Safety Recall Launch Notification

Campaign #	NHTSA ID	Description	Check Headlamp Adjustment Caps
2025060005	25V365	25P8291017

Recall Campaign Bulletin

CAMPAIGN NO.	2025060005
CAMPAIGN DESC.	25P8291017
NHTSA ID	25V365
SUBJECT	Check Headlamp Adjustment Screw Caps
MODEL(S)	GLC (254 platform)
MODEL YEAR(S)	2023
CAMPAIGN POPULATION	127

Figure 1 (Shown on driver side of vehicle)

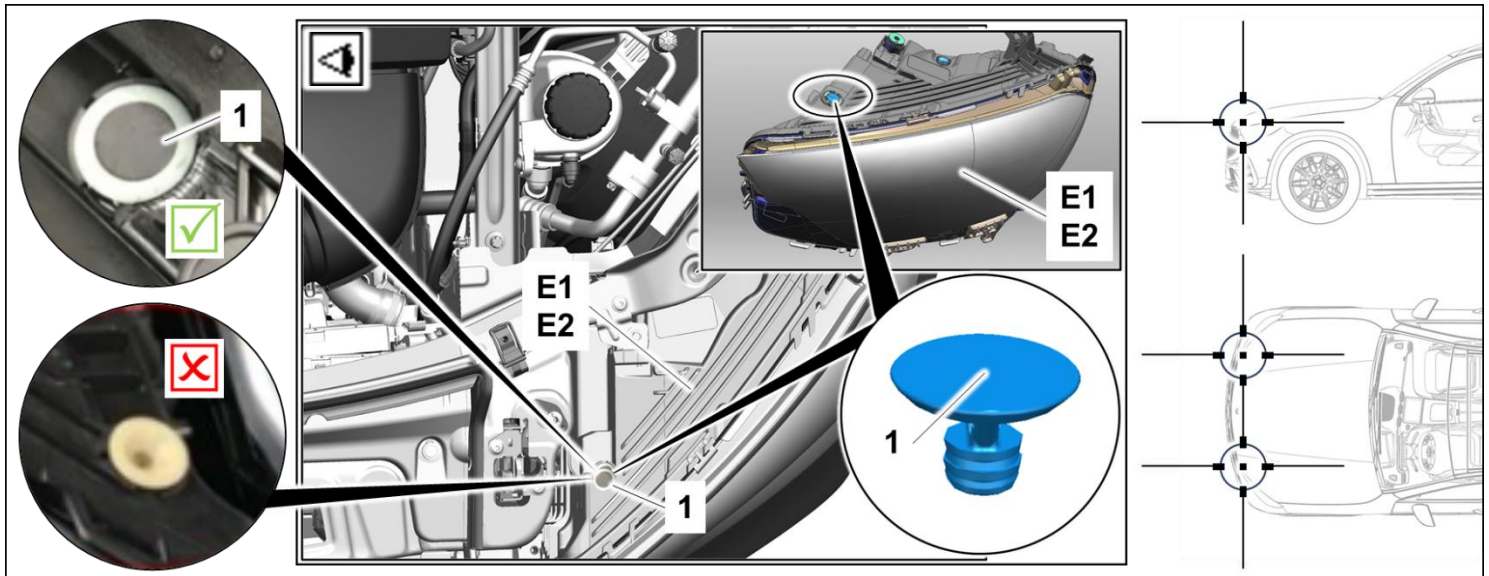
Total Recall Population	127	Model(s)/ Platform(s)	GLC (254 platform)
Vehicles in Dealer Inventory	0		
Model Year(s)	2023		
Issue	Mercedes-Benz AG, the manufacturer of Mercedes-Benz vehicles, has decided that a non-compliance exists on certain subject vehicles. The cap covering the headlamp horizontal aiming screws might not have been installed during vehicle production. In this case, the headlamps are able to be adjusted horizontally, which is not intended. Subsequently, the regulatory requirements of FMVSS 108 might not be met. Horizontal adjustment might negatively impact intended roadway illumination and glare protection, which could increase the risk of a crash.		
What We're Doing	MBUSA will conduct a voluntary recall. An authorized Mercedes-Benz dealer will check the headlamps on the potentially affected vehicles and retrofit the retaining caps if necessary.		
Remedy	The remedy part is available and can be ordered at this time.

1. Check if cap (Figure 1, 1) is installed in the area shown on the front left & right headlamps (Figure 1, E1 & E2).

- a. Caps (Figure 1, 1) **are** installed: **End measure**.
- b. Caps (Figure 1, 1) **are not** installed: Perform **Work Procedure**.

1. Check adjustment setting of front left & right headlamp unit (Figure 1, E1 & E2), and correct if necessary.

i After adjusting the left and right headlamp settings (Figure 1, E1 & E2), the horizontal adjustment for the low beams must not be changed.

2. Install caps (Figure 1, 1) on the left & right headlamp (Figure 1, E1 & E2).
3. End measure.
